# Comhairle Chontae Atha Cliath Theas

## Record of Executive Business and Chief Executive's Order

**Reg. Reference:** SD22A/0286      **Application Date:** 24-Jun-2022  
**Submission Type:** New Application      **Registration Date:** 24-Jun-2022

**Proposed Development:** Demolition of 2 sheds and the construction of 30 dwellings; 1 vehicular and pedestrian link with Main Street, Newcastle; vehicle and pedestrian link with Glebe Square, Newcastle and all associated and ancillary site development works.

Figure 2 Road's layout of 2012 LAP for Newcastle

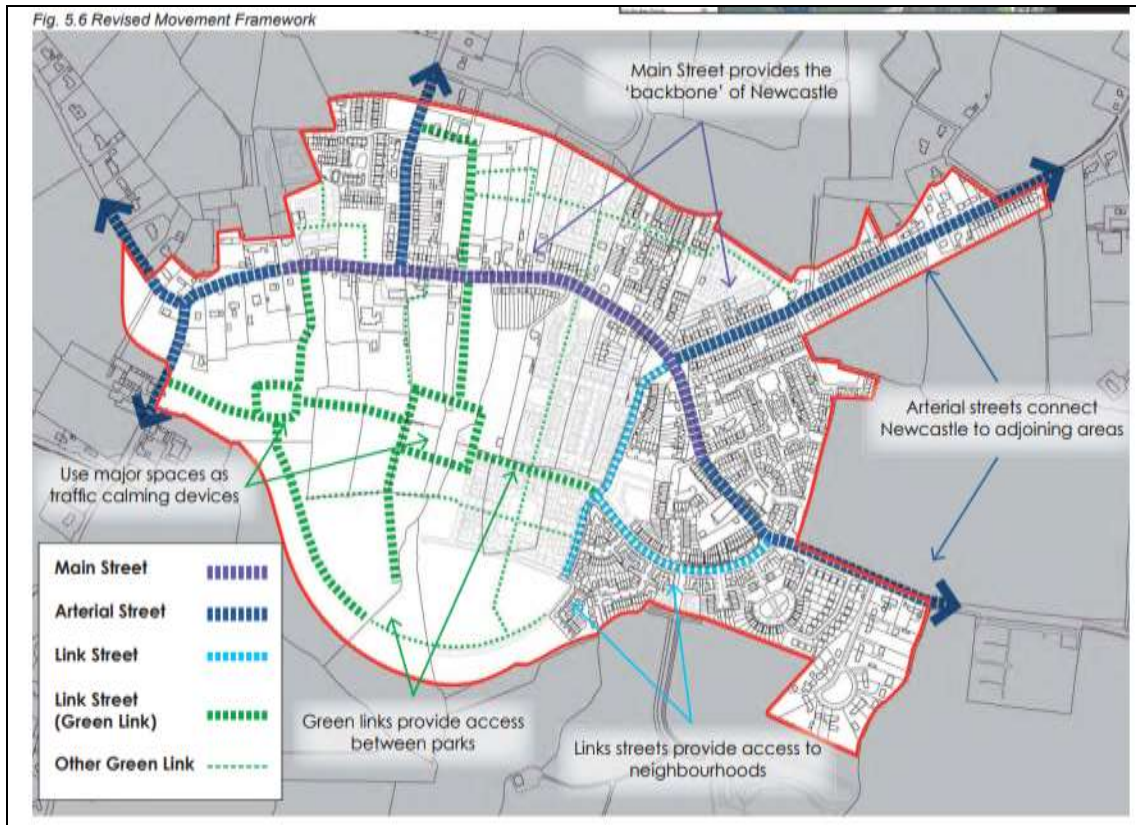
*The development has two vehicular access locations and an additional pedestrian access. The link road through the development to neighbouring Glebe development matches the layout from the 2012 Newcastle LAP. The link to Newcastle Glebe was proposed in a planning application dating back to 2000, shown in Figure 1.*

*the applicant has not provided details of the proposed connection to the Glebe Square Development, the existing boundary wall treatment is required. The applicant should provide an elevation detailing this vehicle access location.*
